UNITED STATES PATENT AND TRADEMARK OFFICE

APPLICATION NO.	FILING DATE	FIRST NAMED INVENTOR	ATTORNEY DOCKET NO.	CONFIRMATION NO.
10/720,430	11/24/2003	Cedric Carlton Lowe	137264	5103

Office Action Summary	Application No.	Applicant(s)	
	10/720,430	LOWE ET AL.	
	Examiner	Art Unit	
	Christopher Verdier	3745

FIG. 4

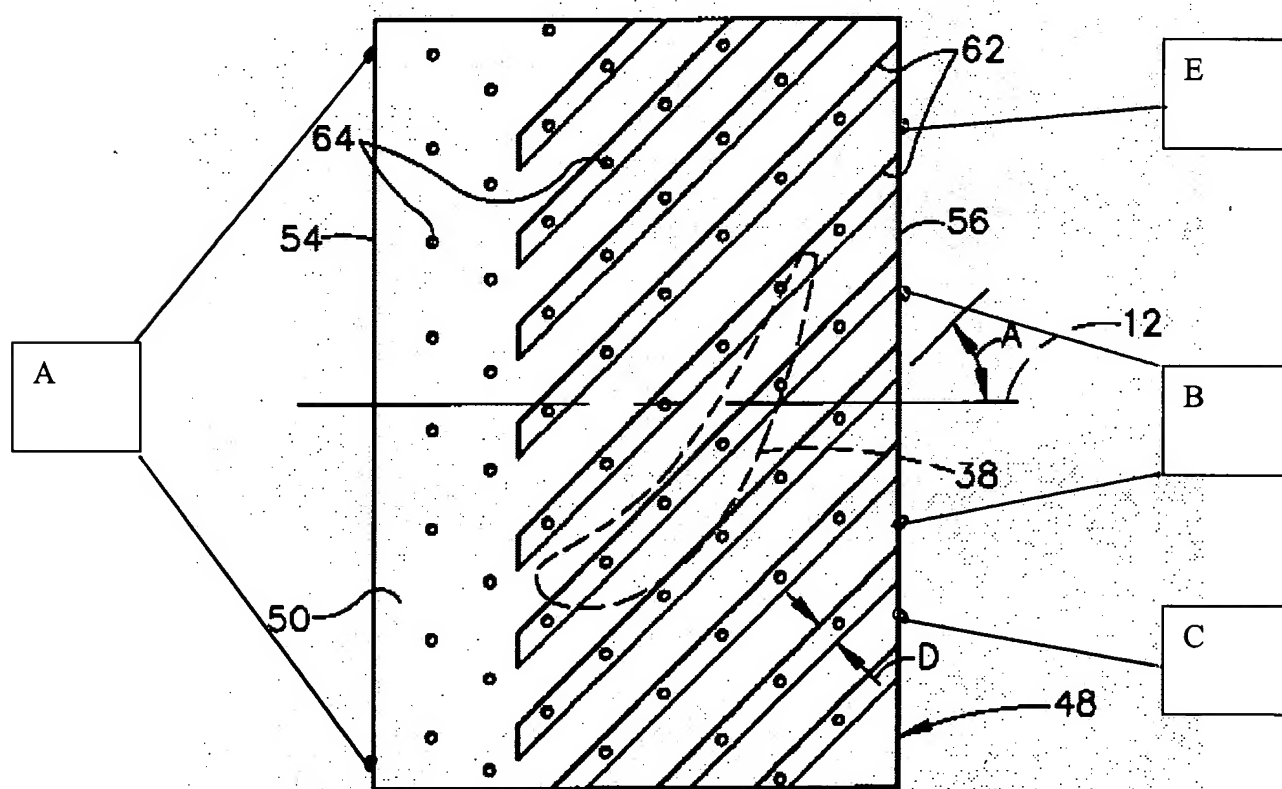
Claims 1-6 and 10-17 are rejected under 35 U.S.C. 102(b) as being anticipated by Lee 6,155,778 (figures 1-2 and 4). See the annotated figure at the end of this paragraph. Lee discloses a turbine shroud assembly cooling element 40 comprising an arcuate panel 48 circumscribed about an axis of rotation 12 and having opposite axially spaced apart forward and aft ends 54, 56, a plurality of cooling apertures 64 extending through the panel, an axially extending midline 12 of the panel parallel to the axis of rotation, a symmetric portion A of the cooling apertures having a symmetrical density of aperture inlets that is symmetric with respect to the axially extending midline, and an asymmetric portion B of the cooling apertures having an asymmetrical density of aperture inlets that is asymmetric with respect to the axially extending midline. There is a high density area C of the cooling apertures in the asymmetric portion of the cooling apertures with the high density area having a higher density of aperture inlets than in the symmetric portion of the cooling apertures, and a low density area E of the cooling apertures in the asymmetric portion of the cooling apertures with the low density area having a lower density of aperture inlets than in the symmetric portion of the cooling apertures. (Note that in high density area C of figure 4, there are four cooling apertures 64 adjacent to aft end 56, while in low density area E of figure 4, there are three cooling apertures 64 adjacent to aft end 56). The high density area is located in a wake region of the arcuate panel, because upstream stator vanes 24 cause a wake of the working fluids flow across the entire panel. The cooling element is a shroud segment and the arcuate panel is a base, and the cooling apertures are convection cooling apertures. The high density area of the convection cooling apertures is located in the wake

region as above. An unnumbered first portion of the convection cooling apertures are axially angled forwardly with respect to the axis of rotation (see figure 2), and an unnumbered second portion of the convection cooling apertures are axially angled rearwardly with respect to the axis of rotation (see figure 2).

Claims 20 and 23-29 (as far as they are definite and understood - assuming “symmetric” in the second to last line of claim 20 to be “asymmetric”) are rejected under 35 U.S.C. 103(a) as being unpatentable over Lee 6,155,778 in view of Proctor 5,169,287. Lee (figures 1-2 and 4, referring to the annotated figure above) discloses a turbine shroud assembly 40 substantially as claimed, comprising a plurality of arcuate shroud segments 48 circumferentially disposed about an engine centerline axis 12, each of the shroud segments including a base having a radially outer back surface, a radially inner front surface, and opposite axially spaced apart upstream and downstream ends 54, 56, a plurality of angled elongated convection cooling apertures 64

(Note that in high density area C of figure 4, there are four cooling apertures 64 adjacent to aft end 56, while in low density area E of figure 4, there are three cooling apertures 64 adjacent to aft end 56). The high density area is located in a wake region of the arcuate panel, because upstream stator vanes 24 cause a wake of the working fluids flow across the entire panel. The cooling element is a shroud segment and the arcuate panel is a base, and the cooling apertures are convection cooling apertures. The high density area of the convection cooling apertures is located in the wake region as above. An unnumbered first portion of the convection cooling apertures are axially angled forwardly with respect to the axis of rotation (see figure 2), and an unnumbered second portion of the convection cooling apertures are axially angled downstream (see figure 2).
